**Central Queensland Coal Project**  
**Chapter 3 - Project Changes and**  
**Responses to Regulator Comments**

**Central Queensland Coal**

**CQC SEIS, Version 3**

**October 2020**

Figure 3-14: Mamelon offset connectivity

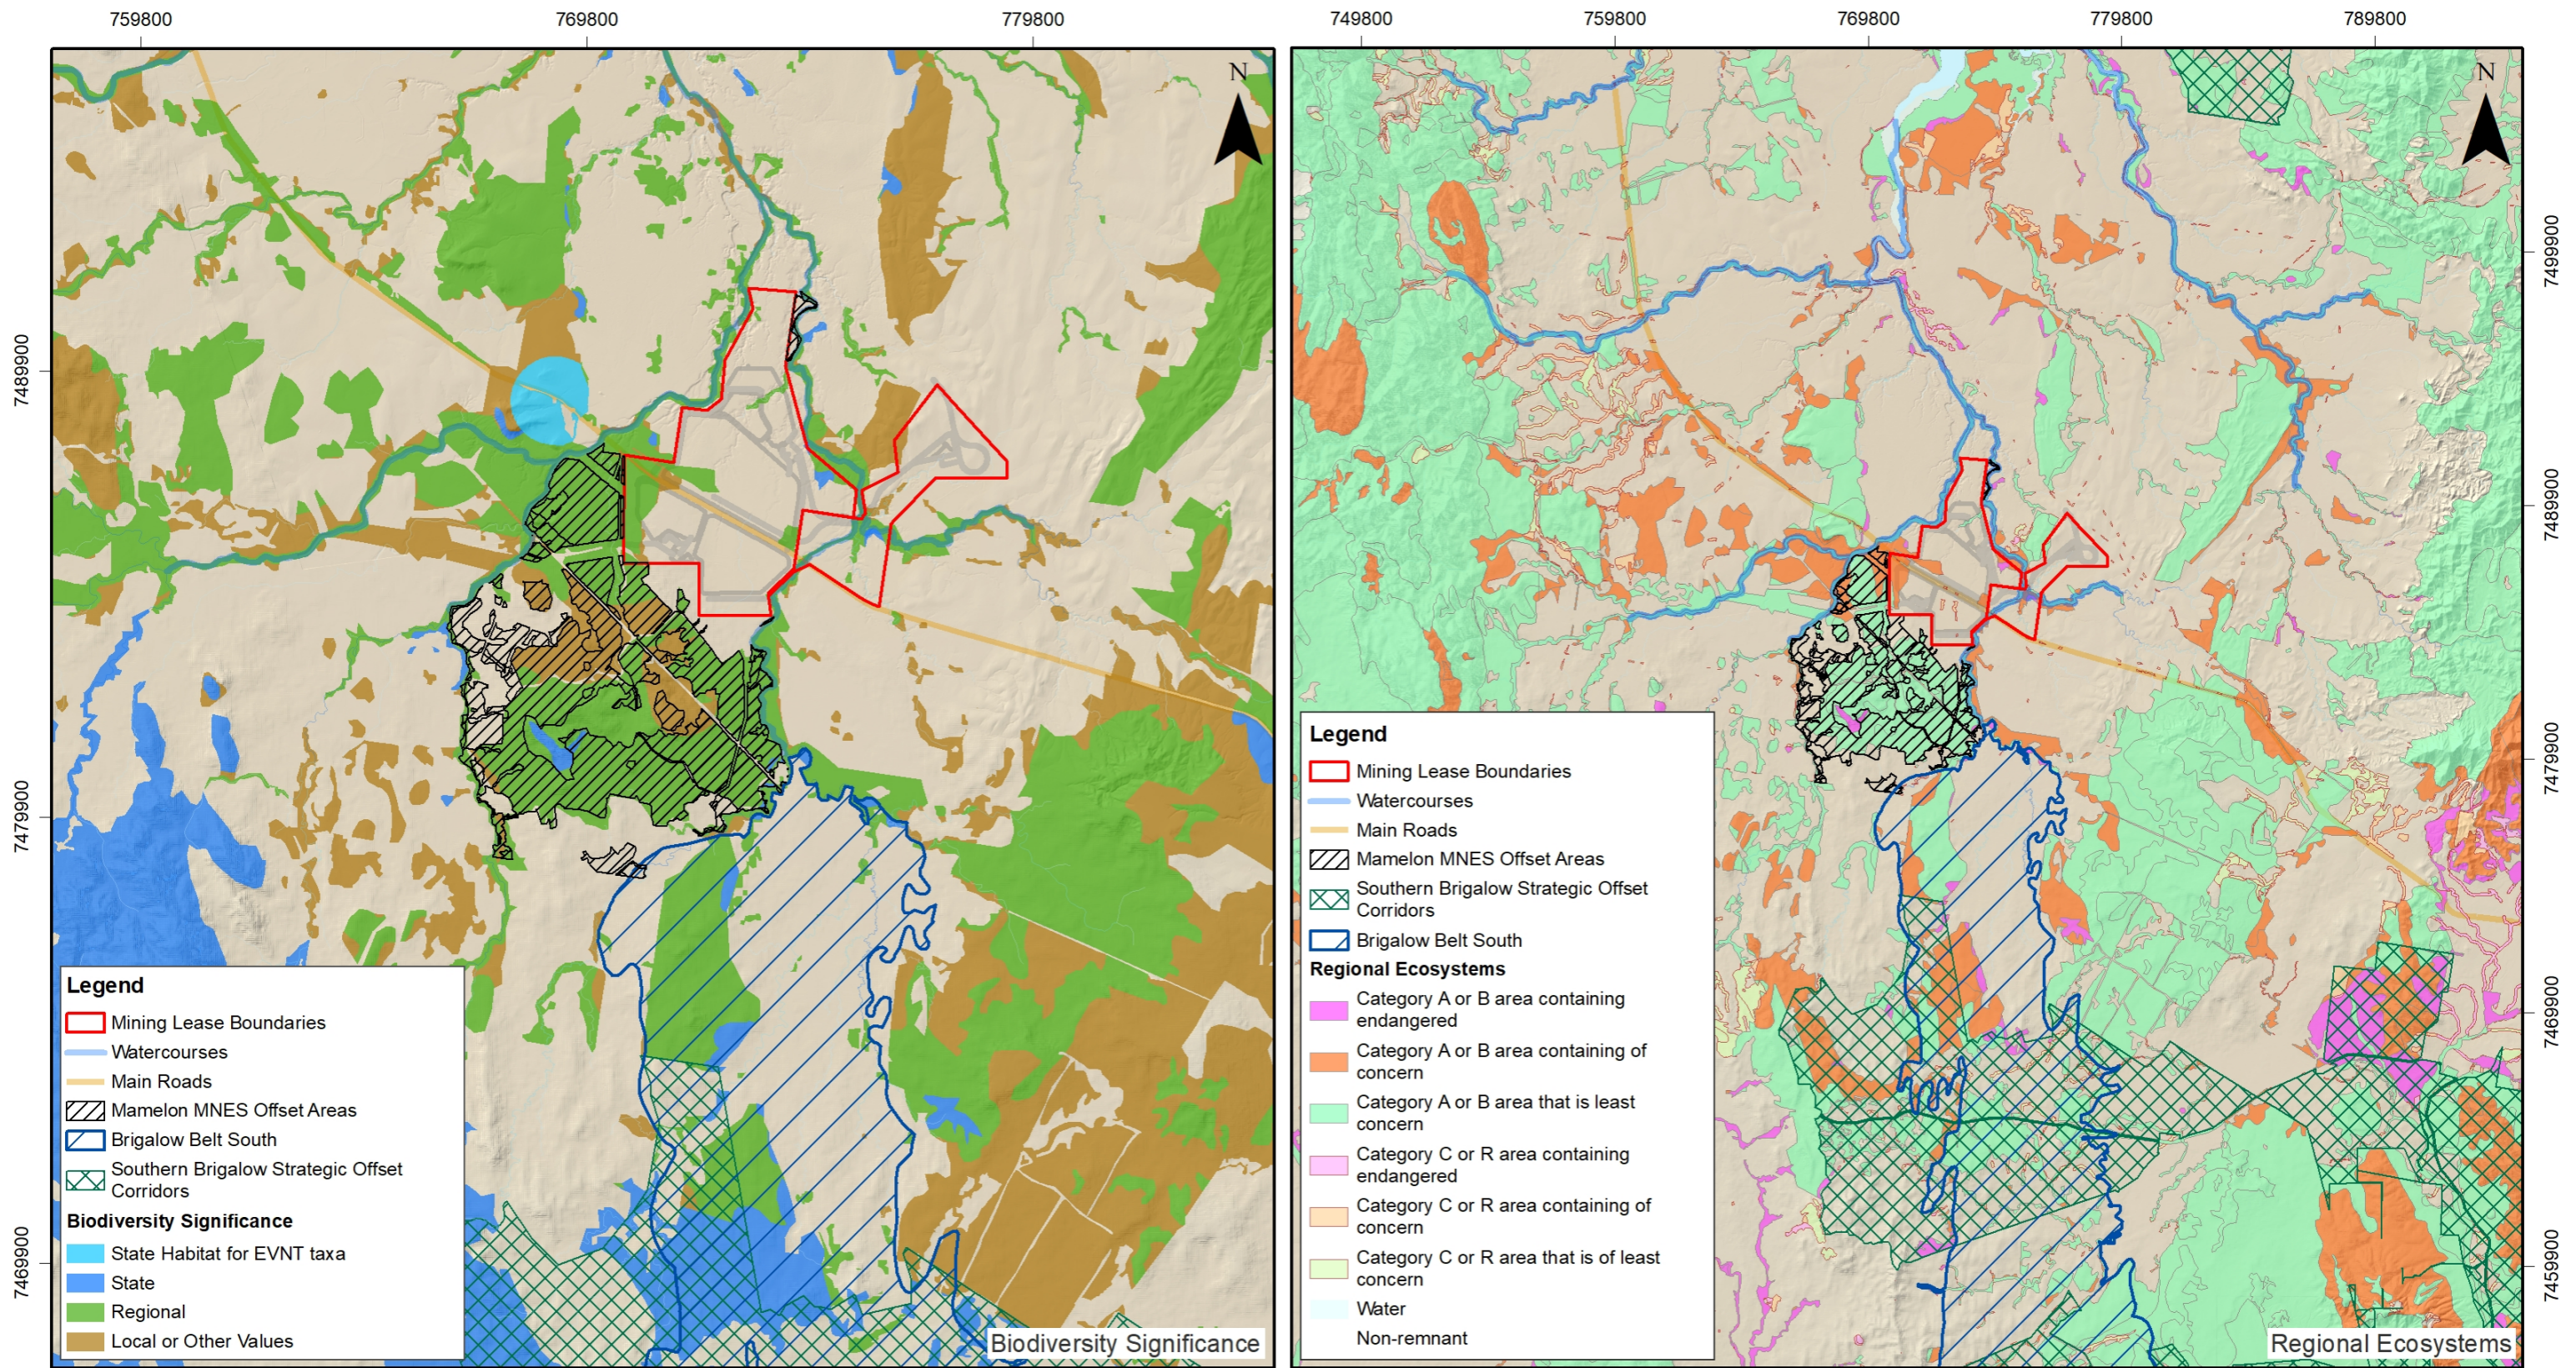
#### **3.6.4.5.5 Proposed offset areas do not provide connectivity with habitat in the Southern Brigalow region.**

As illustrated in Figure 3-14, the Southern Brigalow Belt strategic offset corridor is located 4.5 km to the south of the Mamelon offset area, and the offset area is indirectly connected to this mapped corridor by a large patch of remnant vegetation containing endangered, of concern and least concern regional ecosystems.

In addition, as illustrated in Figure 3-14, within the wider landscape Mamelon is well connected to large remnant habitat patches to the west; remaining contiguous with an extensive tract of remnant vegetation, which includes Tooloombah Creek Conservation Park, immediately to the north-west of Mamelon. Habitat to the south and south-west of the property remain relatively patchy but maintain connected to extensive habitat associated with Broadsound Range (located to the south and west). Broadsound Range is itself part of a State-wide ecological corridor mapped under the BPA, as are coastal lands to the north and east.
